**Final Environmental Impact Statement (FEIS)**

Project Description: The applicant, Highland Commons, LLC, proposes to construct the mixed residential development, known as Westbourne Estates, on approximately 92.0 acres in the hamlet of Woodbourne, within the Town of Fallsburg, Sullivan County, New York. The proposed development would consist of 331 units, which would include 196 apartment style units (44 of which are existing units) and 135 single (31 single family units) and duplex units (104 two family/duplex units). The project would be divided into three phases of development.

Figure III.E-1 Possible sidewalk options and connectors from the proposed development to the Town.

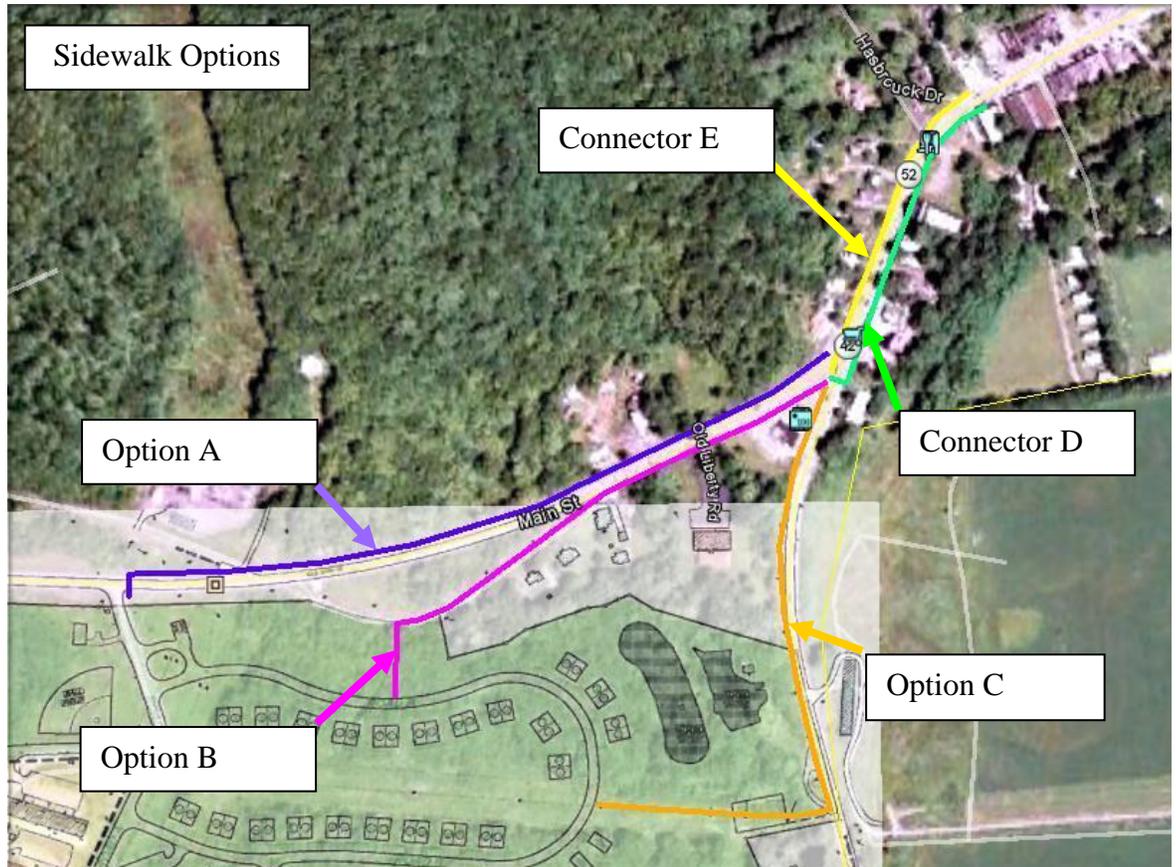
**Comment III.E-10 (Letter 2, Robert Geneslaw, AICP, April 11, 2011):** The Sheet D1, Construction Details has a Typical Road Section that shows a sidewalk location along the edge of roads and includes a note to see plans for sidewalk locations. We found no sidewalks on the plan sheets. The DEIS indicates no intention to provide sidewalks on or off site., but on p. 111.D-6, it notes that one of the Comprehensive Plan goals – “to encourage growth around the Town’s existing hamlet centers” – is met by providing “residences for seasonal and year round occupants within walking distance of the Woodbourne hamlet center”. It is recommended that sidewalks or paths be provided on site, with extensions to the closest sidewalks leading to the Woodbourne hamlet center, possibly using Old Route 42 for a part of the distance. **[Similar comments were made by members of the public during the public hearing on the DEIS: Letter 7, Public Hearing April 14, 2011, Robert Geneslaw, Arthur Rosenshein, Allen Frishman; Letter 8, Public Hearing May 12, 2011, Arthur Rosenshein, Robert Geneslaw, Irv Newmark, Gary Tavormina]**

*Response III.E-10: There are several options for connecting pedestrians from the site into the hamlet of Woodbourne. The figure below highlights these options. Option A includes crossing pedestrians at the site driveway and then extending them east along the north side of Route 52 to the intersection of Route 42. This option includes an unsignalized crossing of Route 52 at the site driveway, a segment with a posted 55 mph speed limit, but does not require any roadway crossings at the Route 52/42 intersection. Option B includes connecting the site through to Old Route 52, and then to Route 42 along the south side of the road. This option uses a segment of the old alignment of Route 52 that now has very little traffic and low speeds before connecting to the 35 mph segment of Route 52. Once at the signalized intersection, a roadway crossing is necessary where pedestrian crossing controls are provided. Option C uses a connection through the east end of the site to Route 42 and then north to the Route 52 intersection. This option requires pedestrians to walk up and down a 14% to 16% grade to Route 42 from the site. Connectors D and E simply depict sidewalks either on the west or east sides of Route 42. Both would connect to existing sidewalks in the hamlet of Woodbourne, but Connector D is already served by the existing pedestrian crossing at the signal.*

*While NYDOT has not indicated a preferable alternative for the sidewalk locations, they have indicated that the sidewalks can be located within the right-of-way of the existing roadways as long as there is an agreement for maintenance between the developer and*

the Town of Fallsburg prior to the construction of the sidewalks. Such construction would also require the issuance of a Highway work permit by the Department prior to the commencement of construction.
